DIVISION OF RECLAMATION, MINING AND SAFETY

**Re: T.H.E. Aggregate Source, File No. M-1977-193,
Preliminary Adequacy Review for Amendment 5 (AM-05)**

The Division of Reclamation, Mining and Safety (Division) has completed its preliminary adequacy review of your 112 construction materials reclamation permit amendment application. The application was received on January 4, 2013 and called complete for review on January 14, 2013. The decision date for this application is April 15, 2013. Please be advised that if you are unable to satisfactorily address any concerns identified in this review before the decision date, **it will be your responsibility to request an extension of the review period.** If there are outstanding issues that have not been adequately addressed prior to the end of the review period, and no extension has been requested, the Division will deny this application.

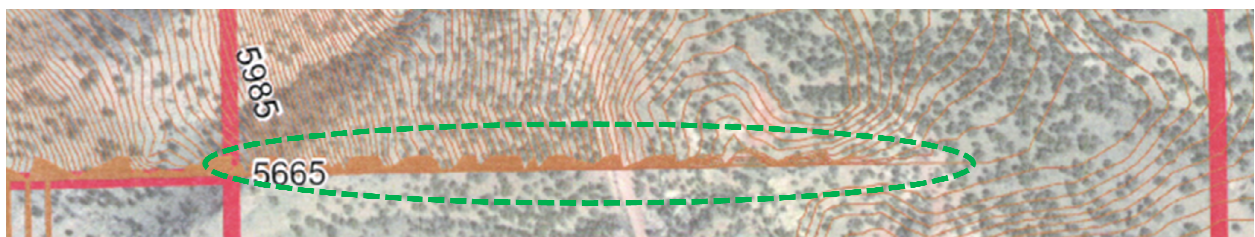
13. The reclamation plan indicates that stormwater retention ponds will remain after mine reclamation is complete. The plan also states the area is zoned industrial/mining with a post-mining use of “open rangeland/wildlife habitat”. The Division strongly encourages breaching the retention pond embankments upon closure unless the landowner has a use for these ponds (e.g., stock pond) and intends to maintain it. As the Aggsources, LLC is

the landowner, please provide some discussion as to how the retention ponds will be maintained in order to prevent a potentially catastrophic release of sediment in the future after the ponds fill with sediment and breach during a storm, or overtop and breach during a storm greater than the design storm.
